**MEETING OF THE DESIGN REVIEW BOARD
MORRIS N. BROAD COMMUNITY CENTER
1175 95TH STREET
BAY HARBOR ISLANDS, FL 33154**

REVISION # 1 REVISION DATE: 07/18/23

Subject: Site Development Plan Application - Revision
Proposed New 9 DU Multifamily Residential Complex
Revisions to Approved Site Development Plan
1055 93rd Street
Bay Harbor Islands Acct. No. SPR22-000026
MMPA Acct. No. 01-0702-1144

Revision to Approved Planning and Zoning Board Submission

Sheet A-15, Level 5 Floor Plan

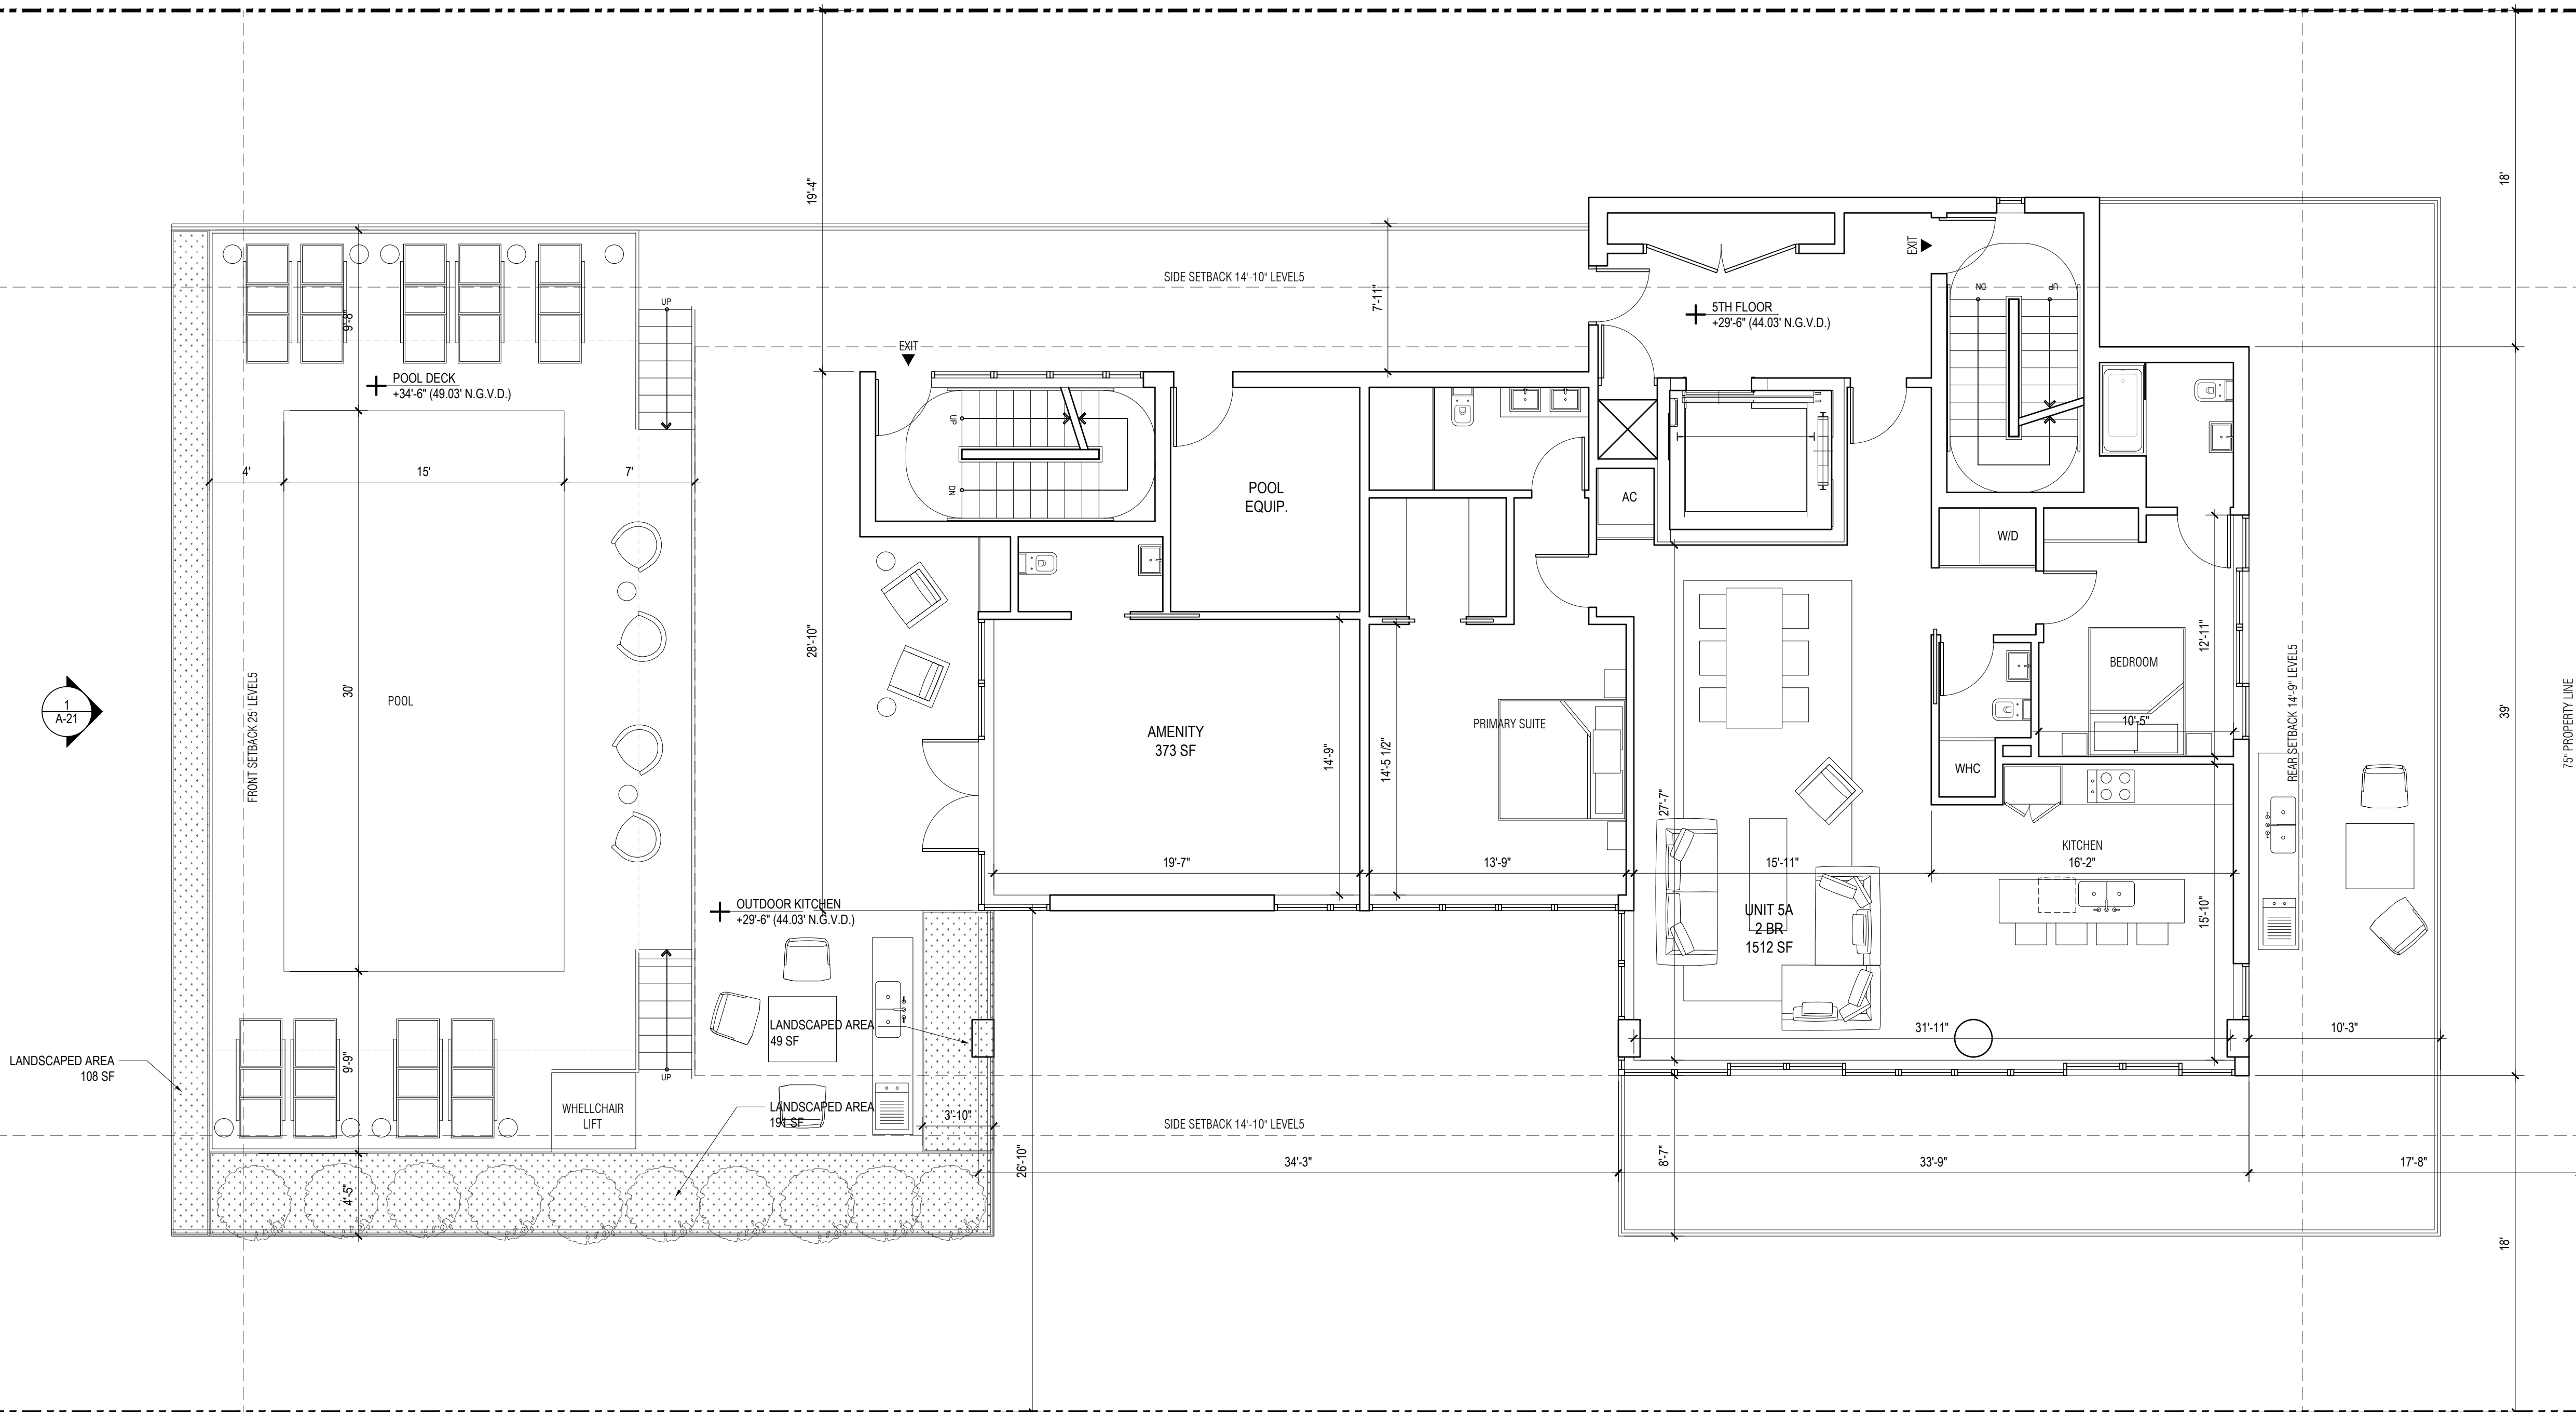
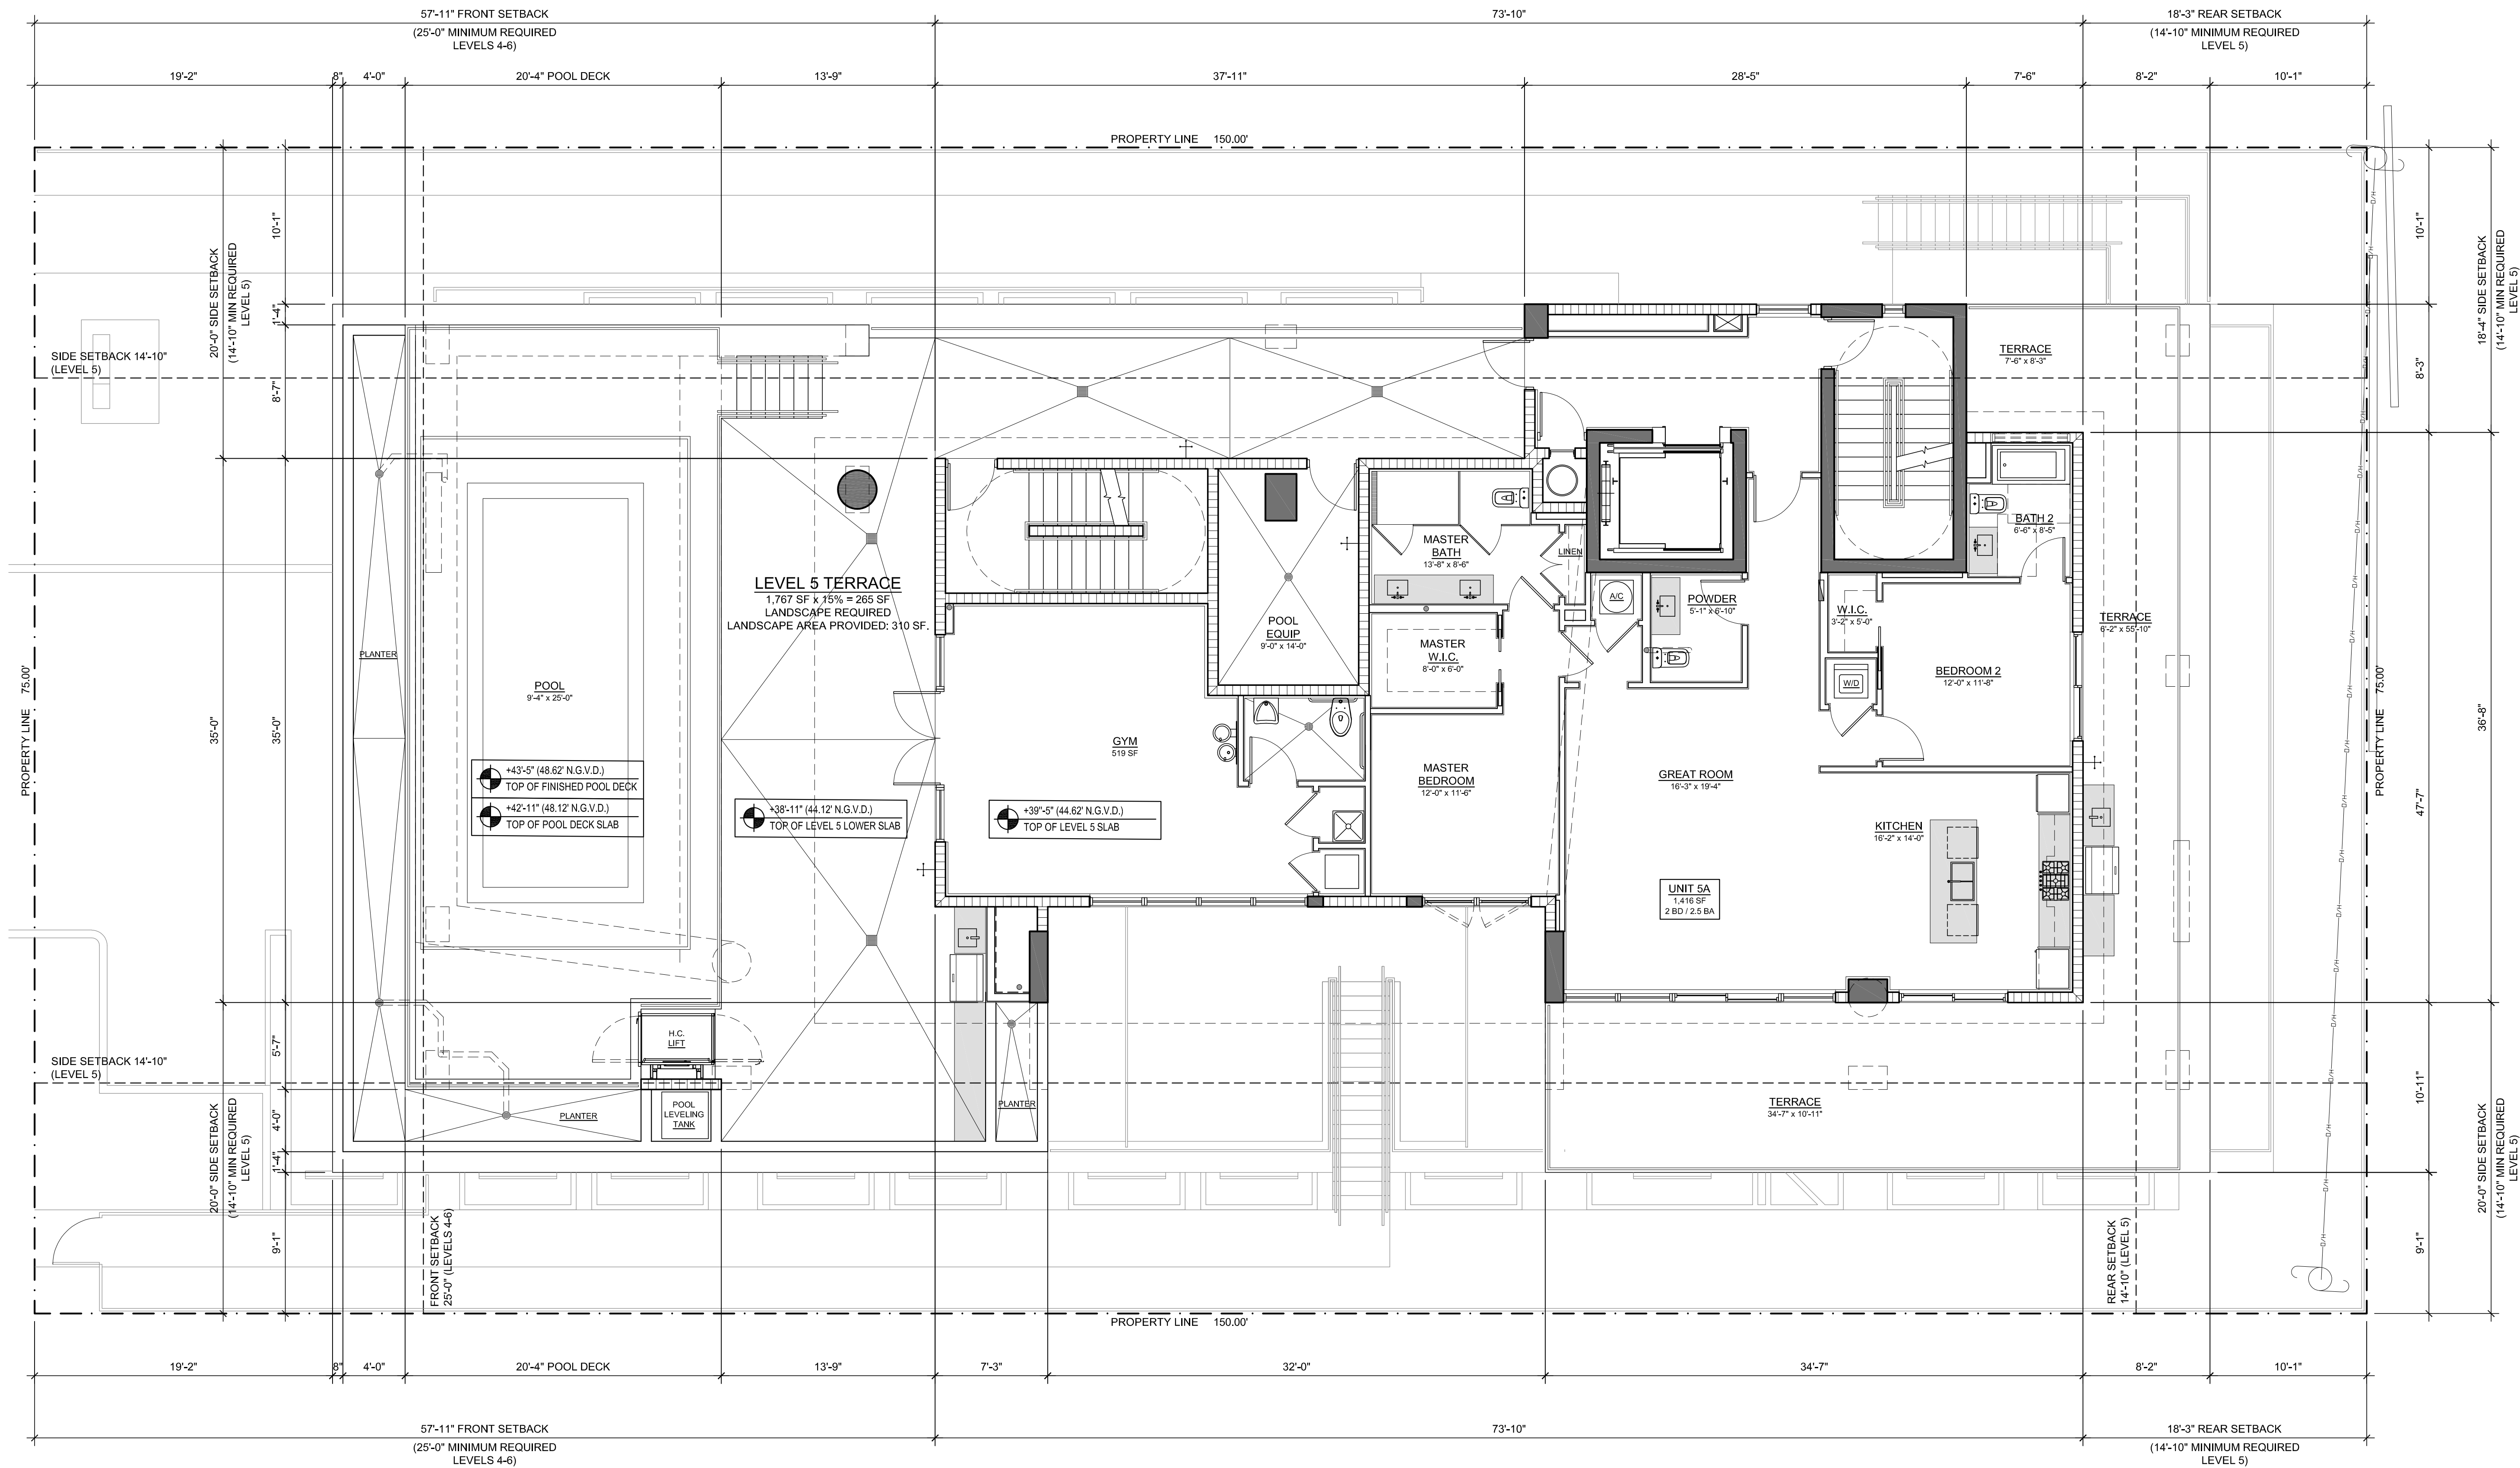
1. Modifications to the floor plan to reduce the north facing balcony along the rear elevation due to the proximity to the FPL power lines that are running along the rear property line
2. Modifications to the exterior window/door placements and sizes due to changes to the unit layouts and coordination with Structural
3. Modifications to the interior unit layouts
4. Modifications to the upper and lower pool deck and planter locations/sizes as per coordination with the Pool and Structural Engineer
